TUDHOPE MOTOR Co.	
ORILLIA CANADA	
CLUTCH FACING.	
DRAWING No. - AB-13	
MAT'L - LEATHER	
NO. REQUIRED - 1	
DRAWN BY - WJW	CHECKED BY -
TRACED BY - FLG	APP. BY -
DATE - 4-24-1911

AB-13.

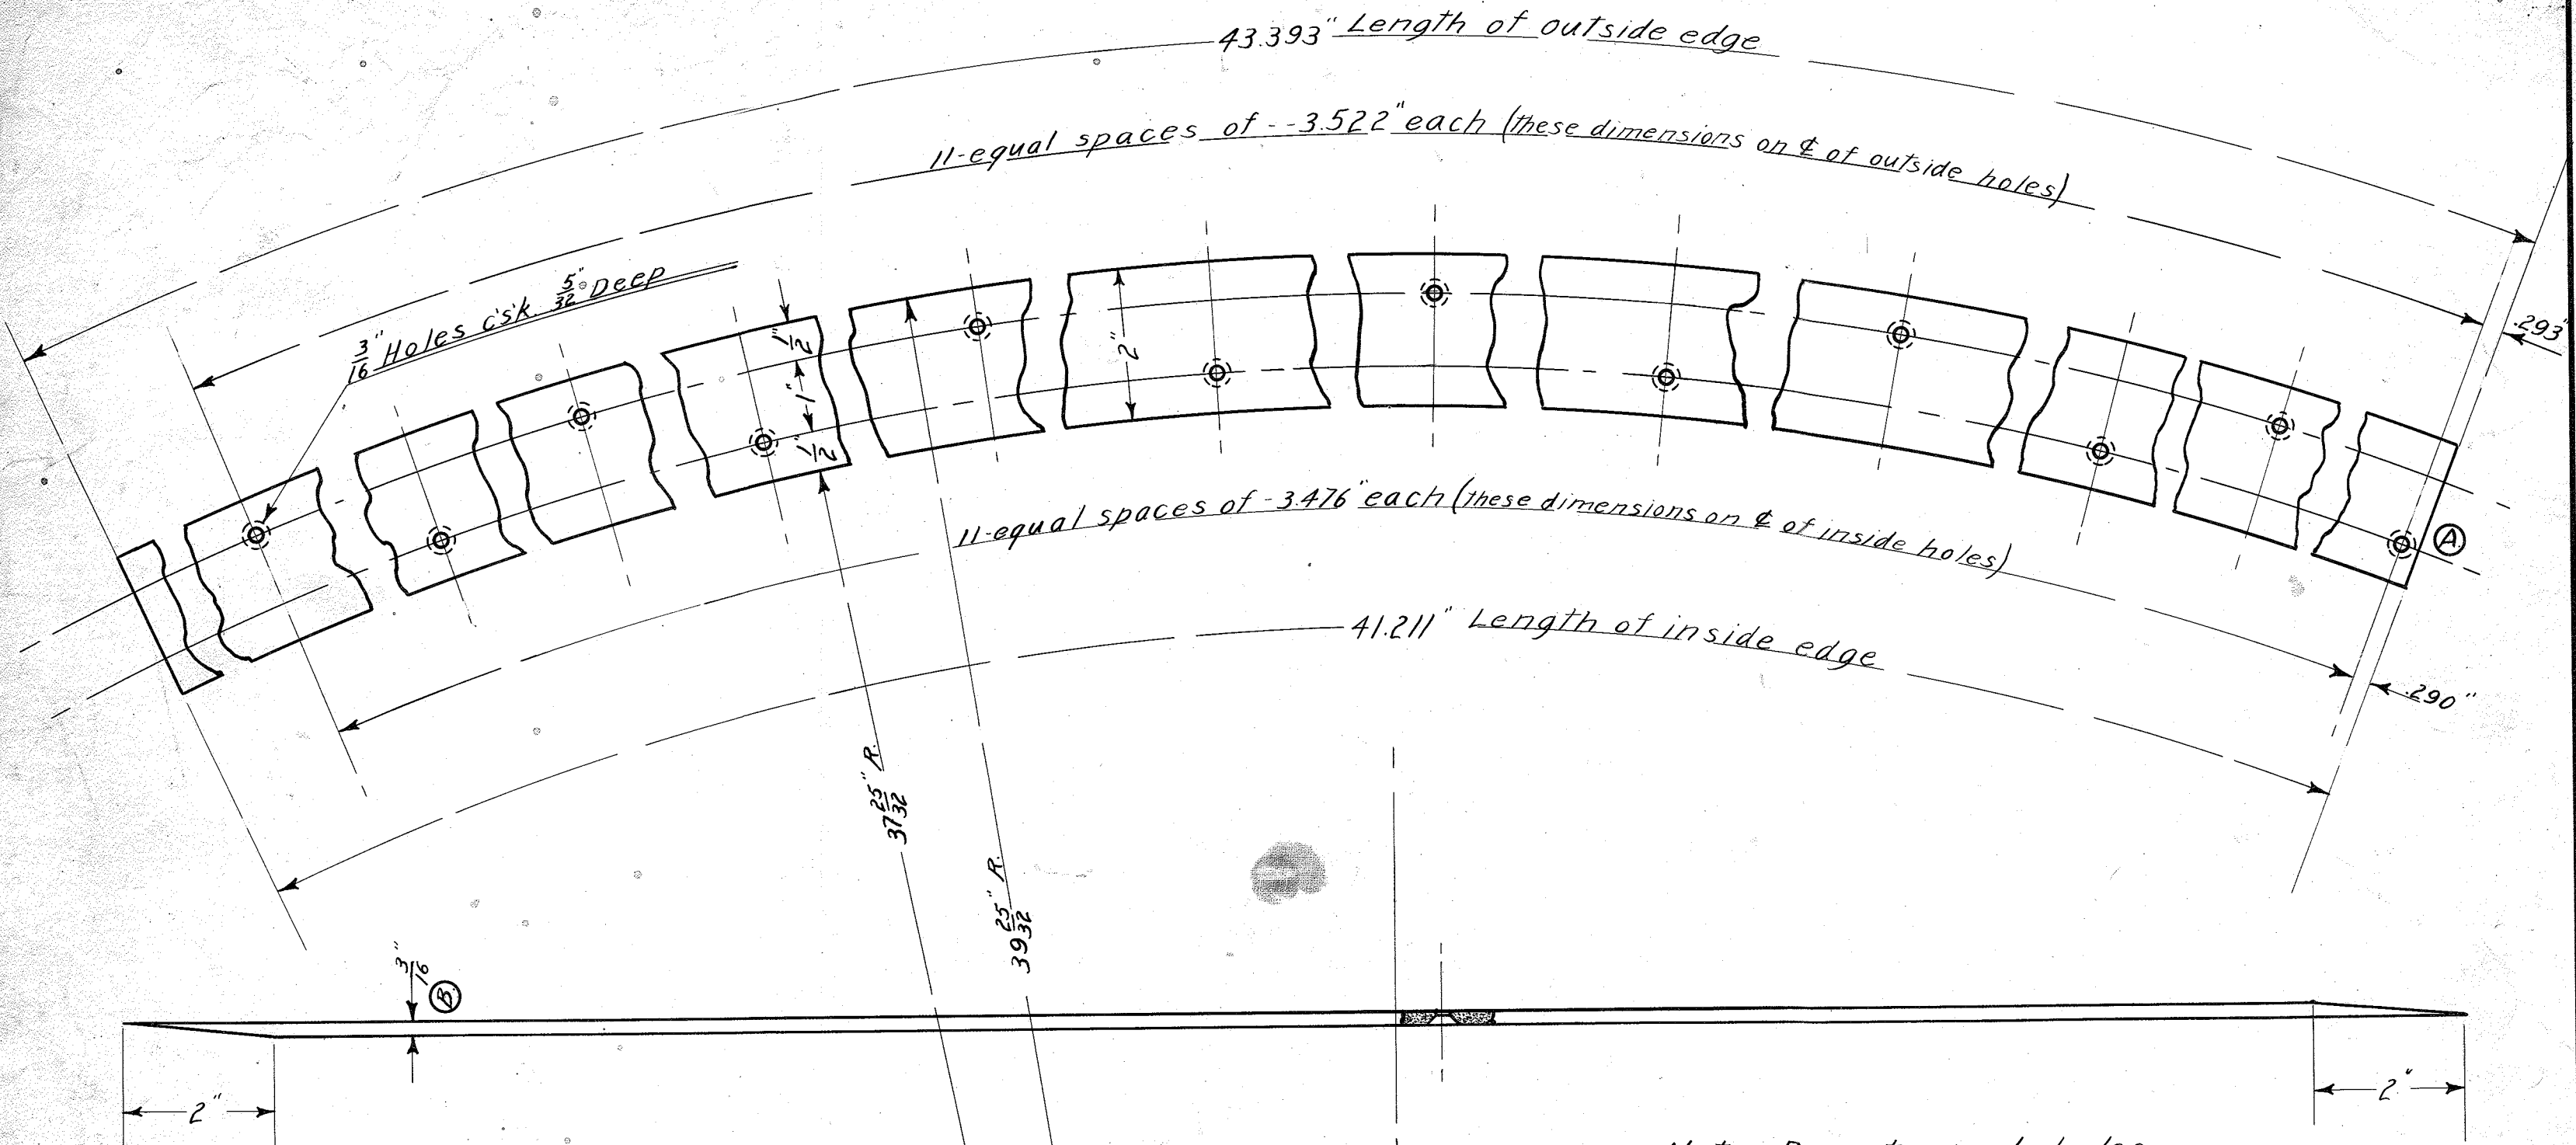
Ⓐ Position of holes changed 4-24-11
 Ⓑ From $\frac{1}{4}$ " to $\frac{3}{16}$ " --- 4-25-11
